City of Portland, Maine – Building or Use Permit Application 389 Congress Street, 04101, Tel: (207) 874-8703, FAX: 874-8716 -

Location of Construction: 822 Seashore Ave Peaks Island		Owner: William & Robin O'Reilly		Phone:		Permit No: 951215
Owner Address:		Leasee/Buyer's Name:		Phone:		PERMIT ISSUED Permit Issued: NOV 17 1995 CITY OF PORTLAND
Contractor Name: D.L. Brown Construction		Address: 52 Johanness St Portland, ME 04103		Phone: 761-0227/Darren		
Past Use: 1-fam		Proposed Use: Same		COST OF WORK: \$ 37,000.00 PERMIT FEE: \$ 205.00 FIRE DEPT. <input type="checkbox"/> Approved <input type="checkbox"/> Denied INSPECTION: Use Group 43 Type 5B Signature: [Signature] Signature: [Signature]		
Proposed Project Description: Make Renovations				PEDESTRIAN ACTIVITIES DISTRICT (P.A.D.) Action: <input type="checkbox"/> Approved <input type="checkbox"/> Approved with Conditions <input type="checkbox"/> Denied Signature: _____ Date: _____		Zone: IR-1 CBL: 091-G-036-038 Zoning Approval: [Signature] Special Zone or Reviews: <input type="checkbox"/> Shoreland <input type="checkbox"/> Wetland <input type="checkbox"/> Flood Zone <input type="checkbox"/> Subdivision <input type="checkbox"/> Sit

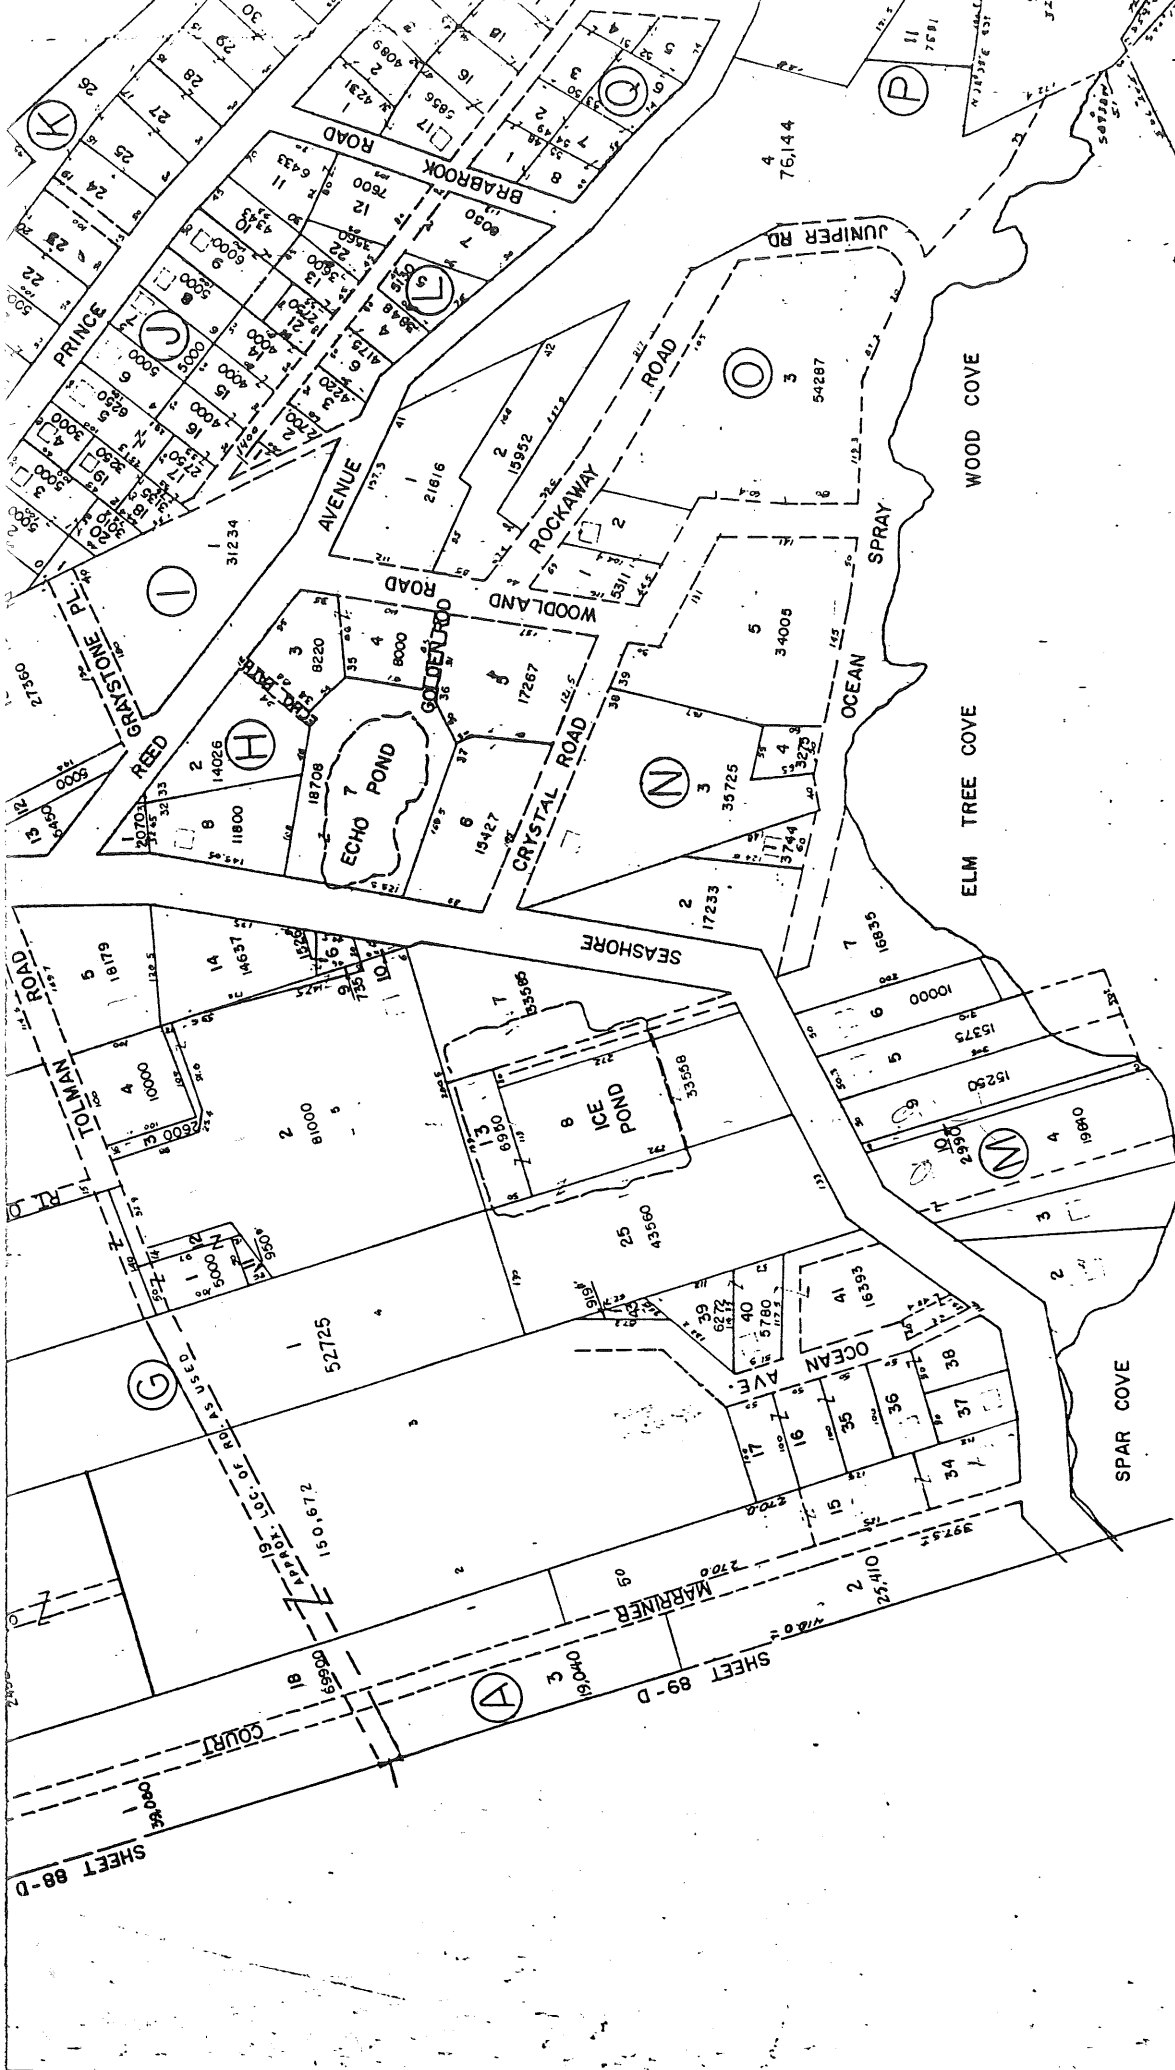
condition → Rear Yards - 30' req - 8' existing - rebuilding shed & going up one story
Side Yards - 20' req - 20' & 22' 6" shown
Front Yards - 30' req - 39' shown
Projections -
Height -

Sec 14-436 allows
A 2nd story to be
added on top

within 250' of high water - appears to be more
than 75' setback even with proposed
deck

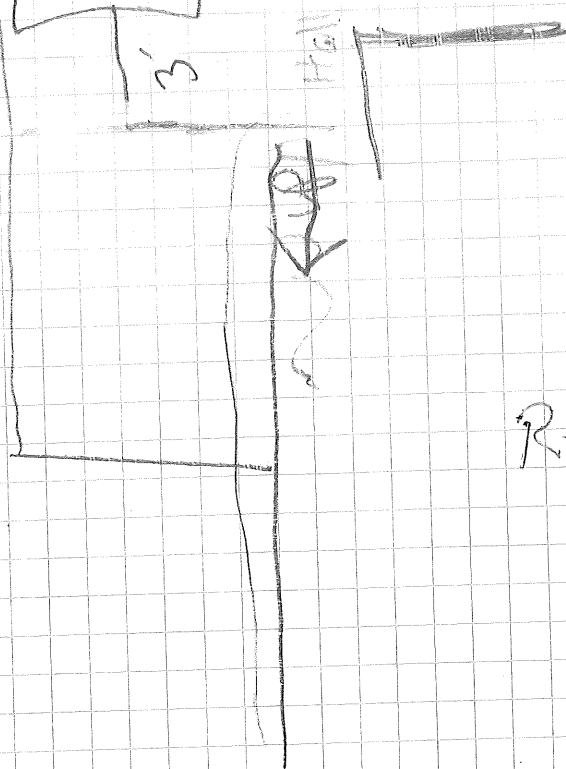
1. The existing shed style room depicted as #1 on your plot plan is nonconforming as to setbacks with current zoning ordinances. In order to preserve this nonconformity, you must take care in how you approach the proposed work. You would not be allowed to demolish the entire garage, re-excavate then rebuild it in its entirety. Work would have to be done in phases, specifically for the rear setback.

2. This permit is being issued under the condition that construction be in phases so as to preserve the nonconformity of the rear lot line. Should you be unable to comply with these requirements, a 30' rear setback shall be required.
